Merton Council

Planning Applications Committee

7 November 2013

Modifications Sheet.

13/PO952
 247 The Broadway
 Front elevation

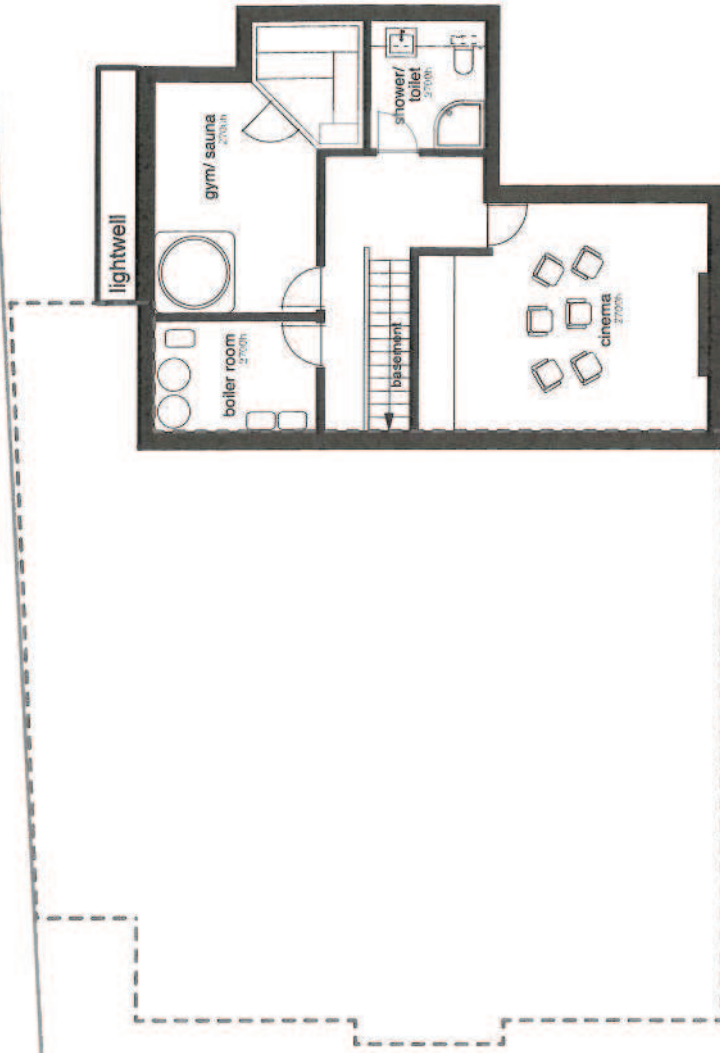
Insert after page 76 drawing 518/480/P4 North Elevation).

Drawing No. DP/19/44/IRG - 5

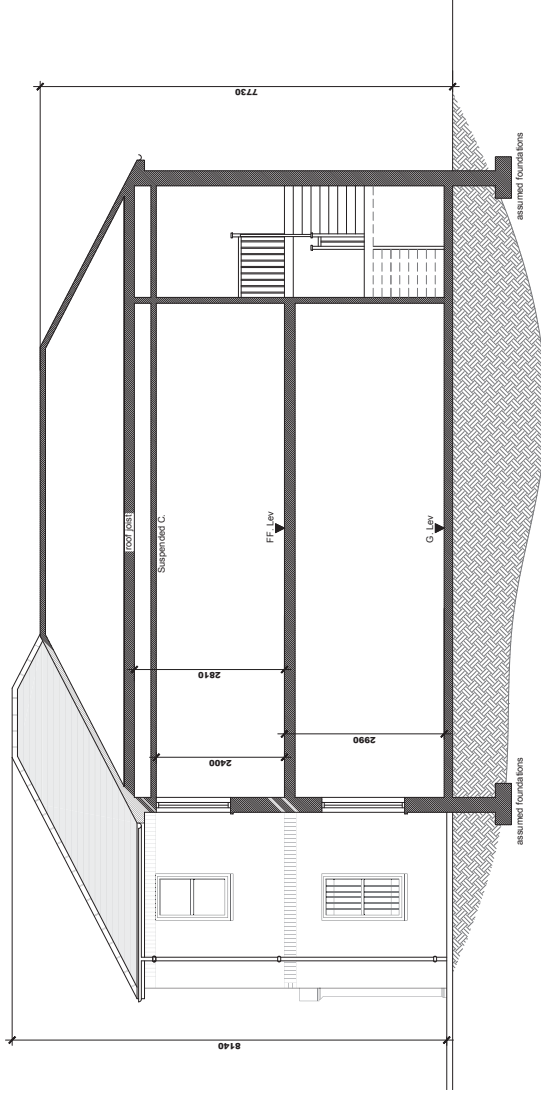
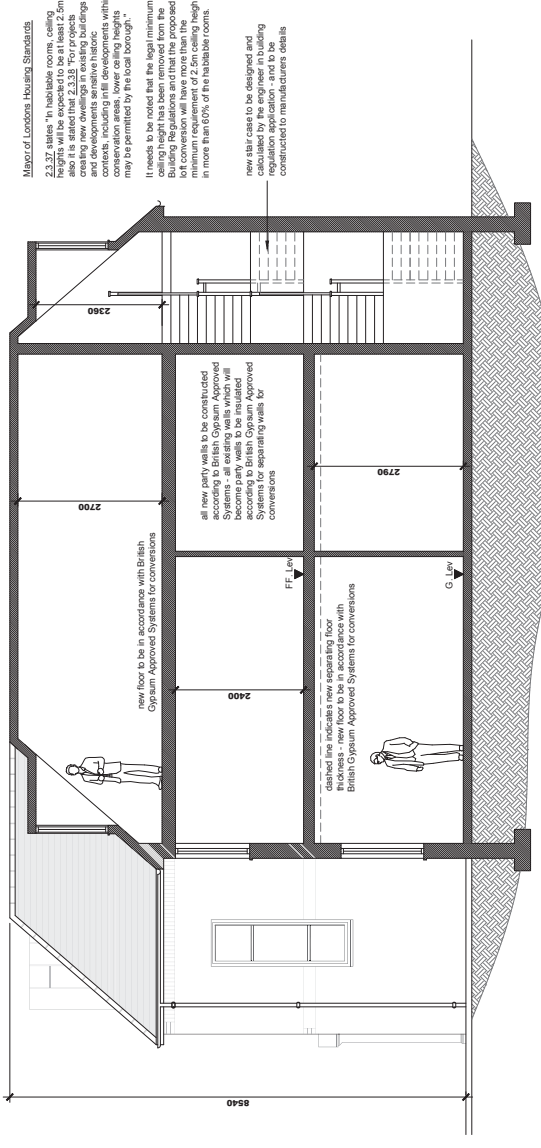
Page 254 Add attached additional drawing [RG-5] ‘existing and proposed cross sections’.

Drawing No. DP/19/44/IRG - 2

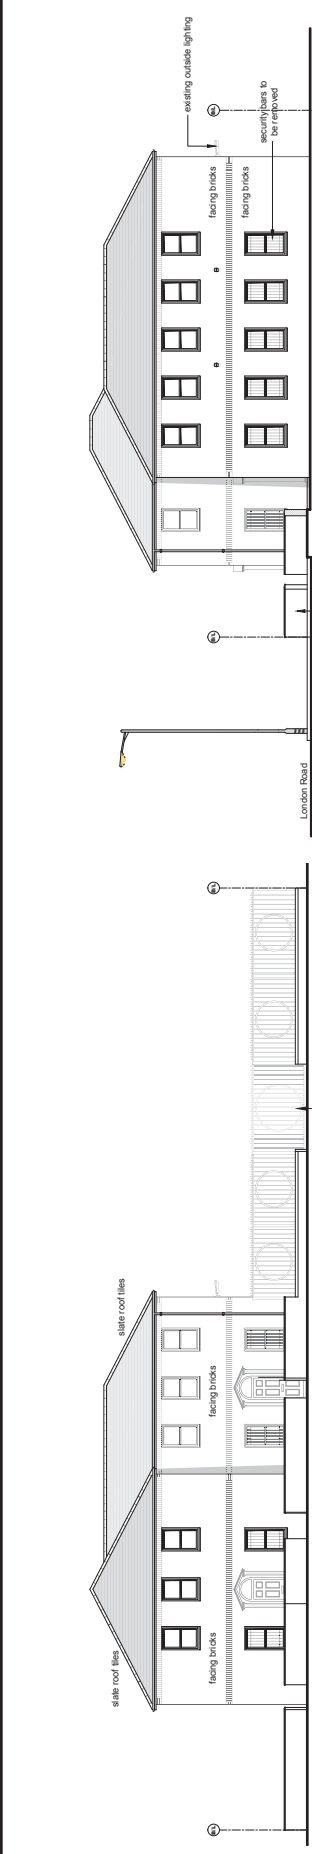
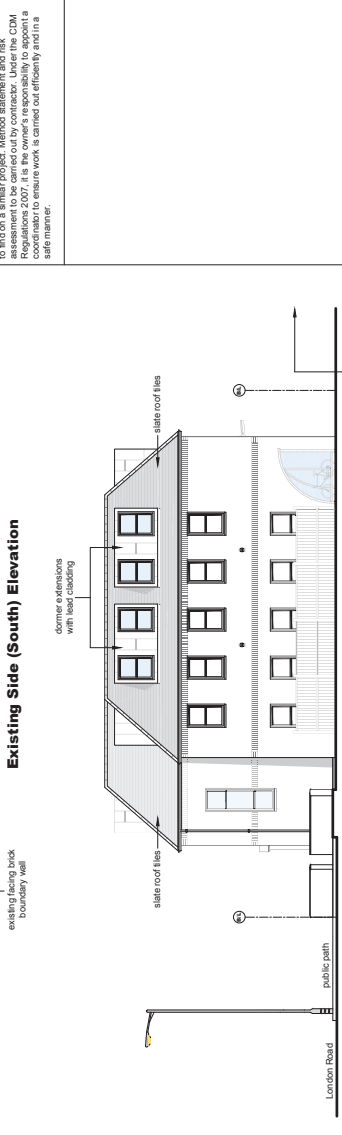
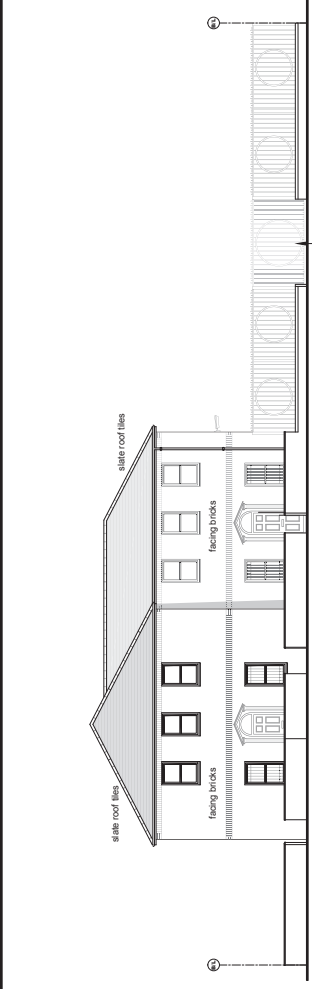
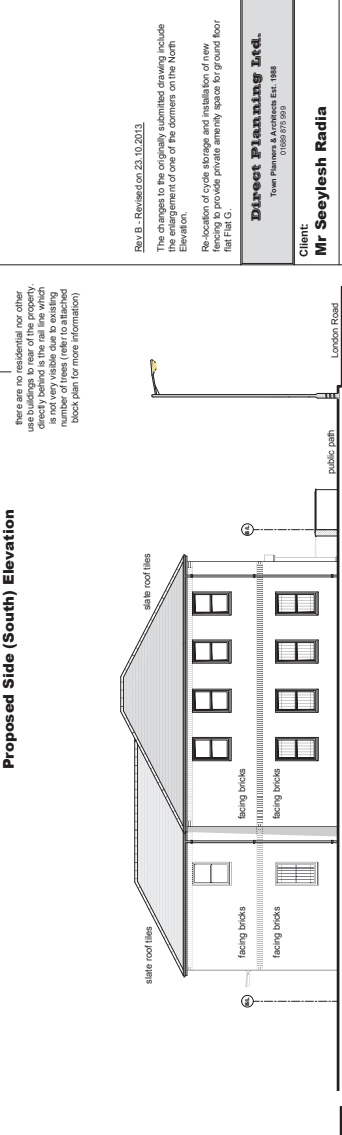
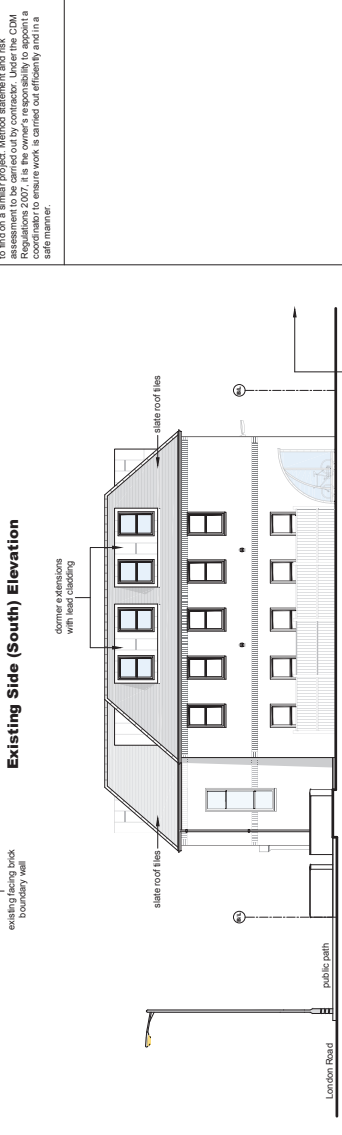
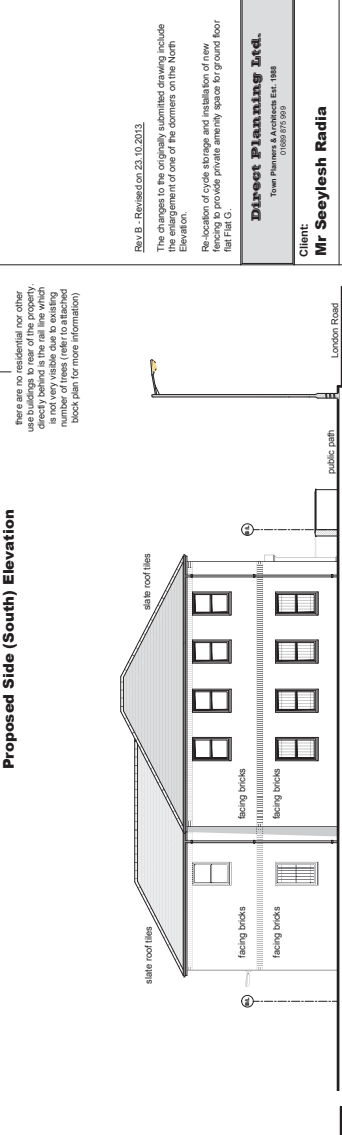
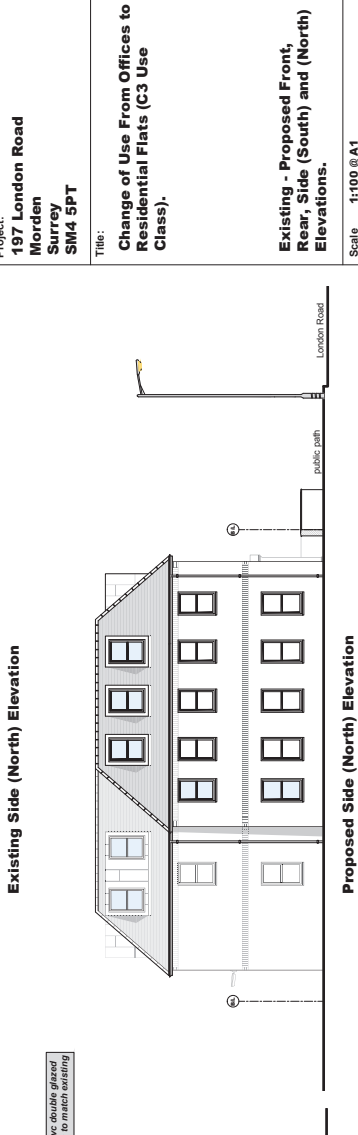
Page 253 - replace drawing with [RG-2B] ‘existing and proposed front, rear, side south and north elevations’

The changes to the originally submitted drawing include the enlargement of one of the dormers on the North Elevation.

Scale: 1:100 @ A1
Date: February 2013
Drawn: Erap Semi
 Checked:
 Approved:
 Building Regulations:
 Construction:
 Drawing No. **DP/19/44/RG - 1**

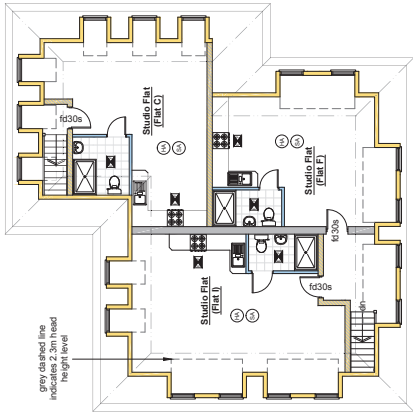
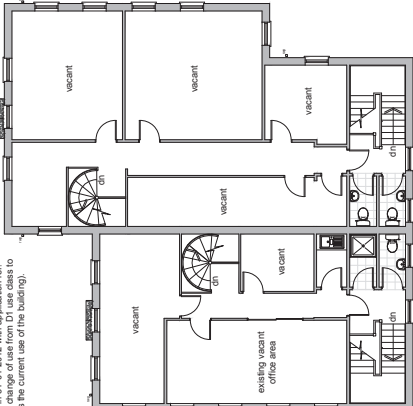
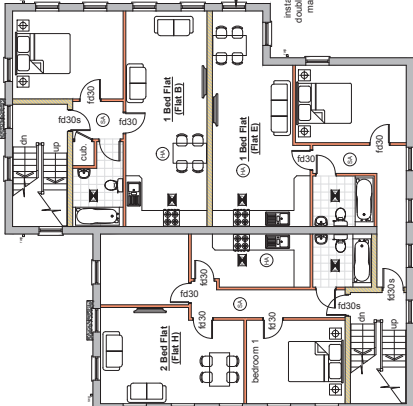
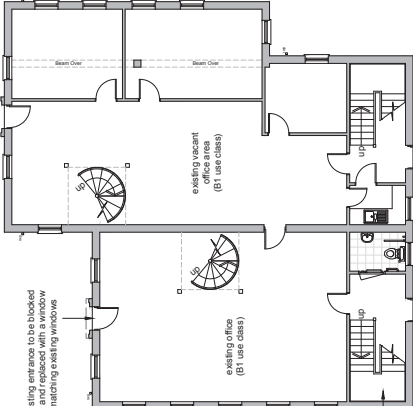
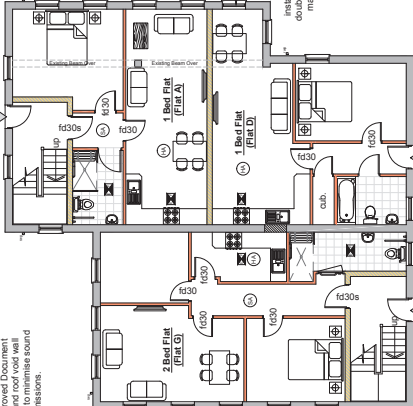
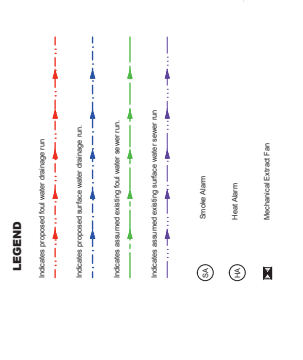
Page 252 – replace drawing with [RG-1B] ‘existing and proposed ground, first, loft and roof plans’

Riv.B - Revised on 23.10.2012
 The changes to the originally submitted drawing include the enlargement of one of the dormers at Flat F to create a gross floor area of 35m² (floor area as measure from 2.1m dining height).
Direct Planning Ltd.
 Town Planning Consultants
 10088682 Ltd. 1988

Proposed Block Plan.

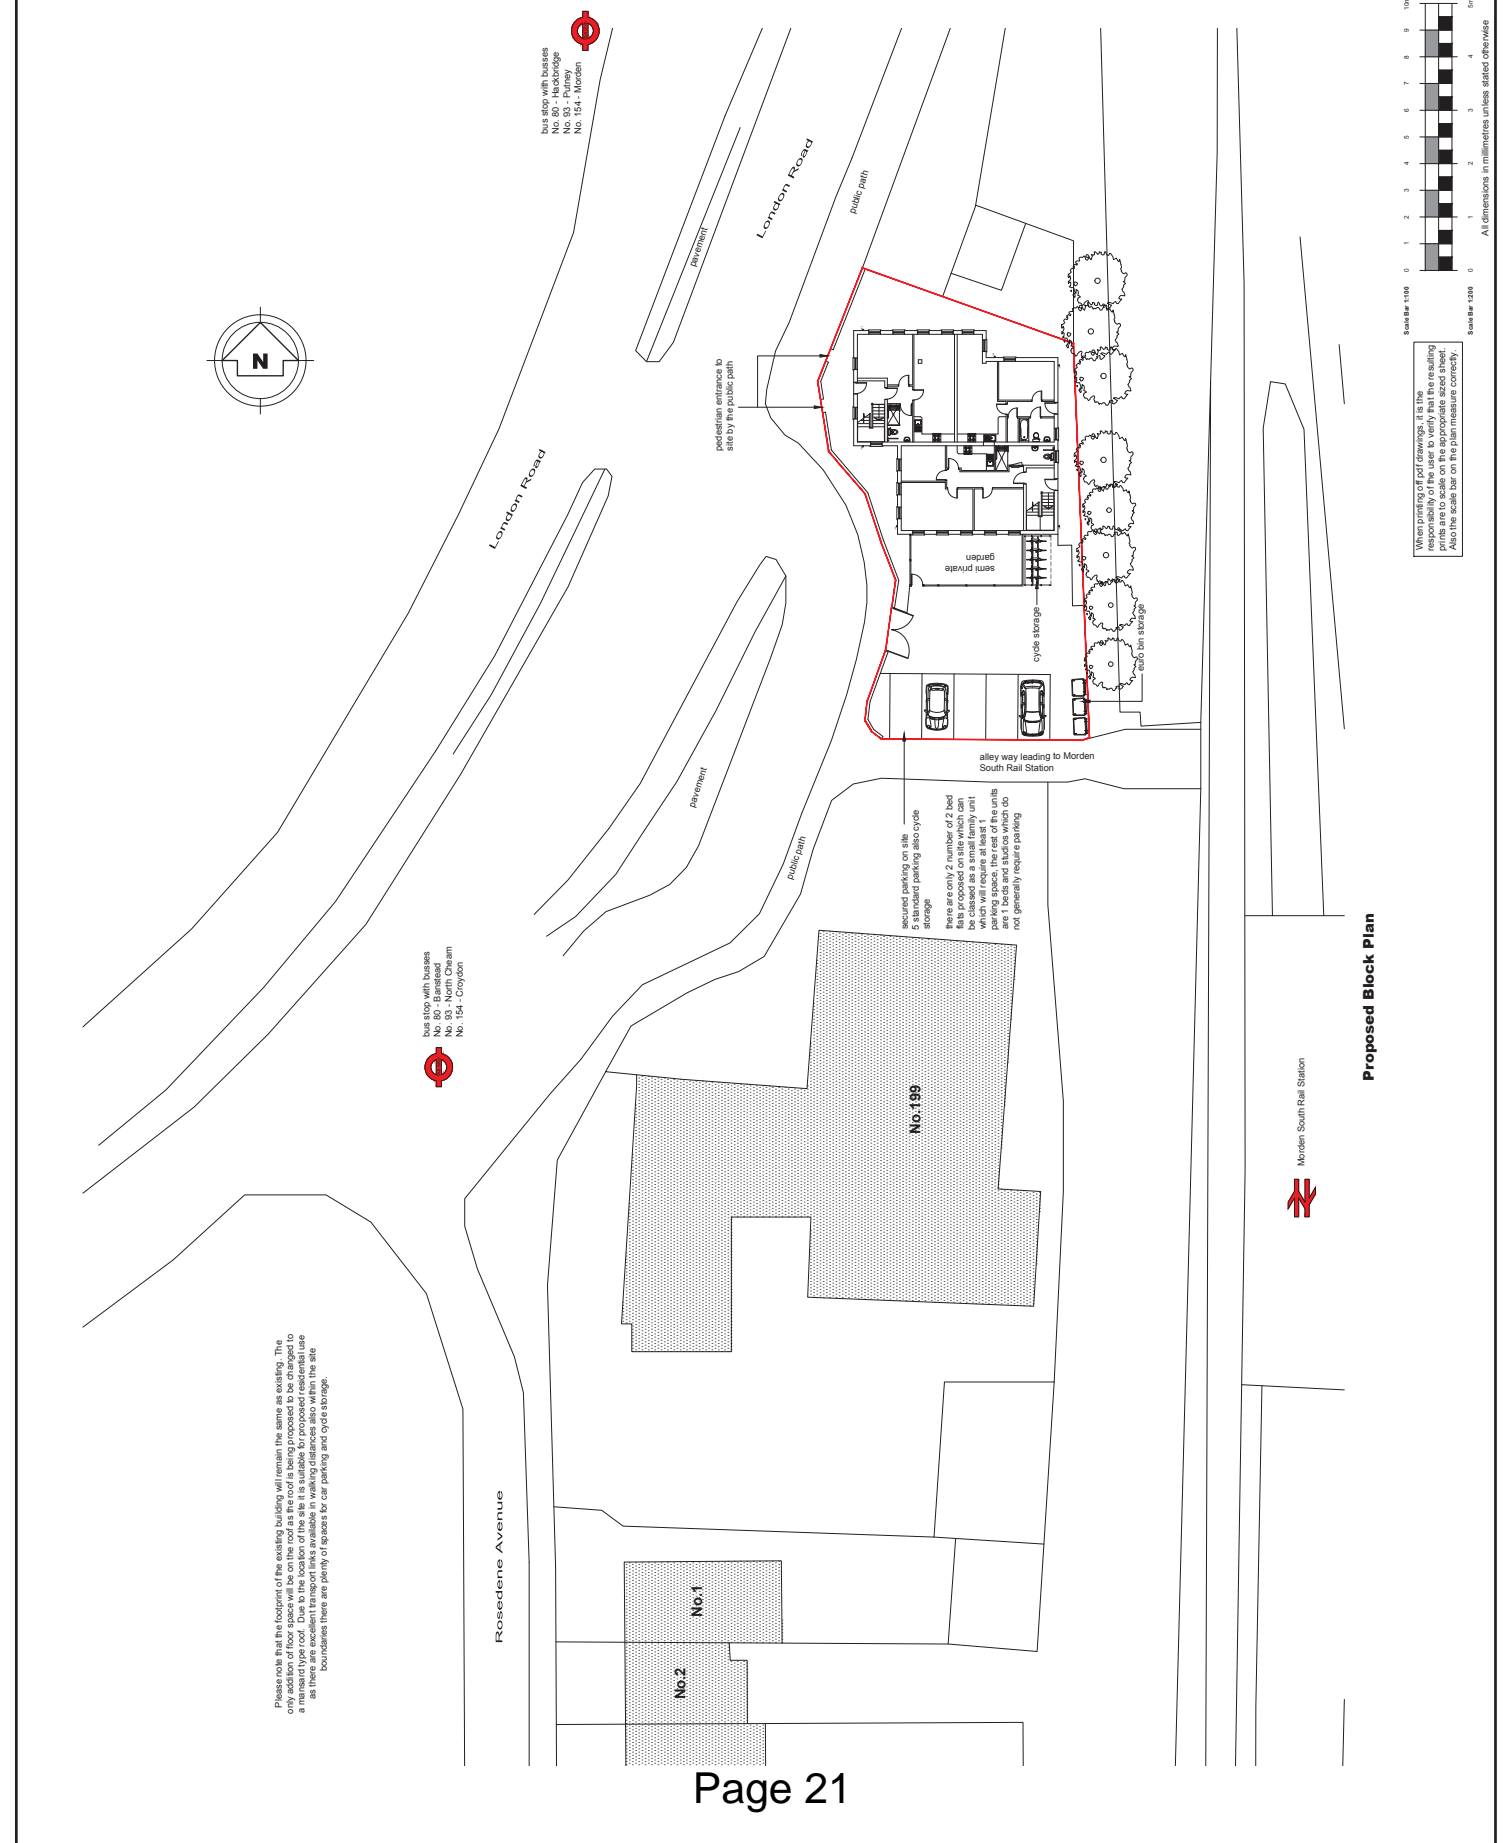
Page 251 – replace drawing with [RG-5B] ‘proposed block plan’

The changes to the originally submitted drawing include the installation of new fences to provide private amenity storage, cycle bin storage and alterations to parking arrangements.
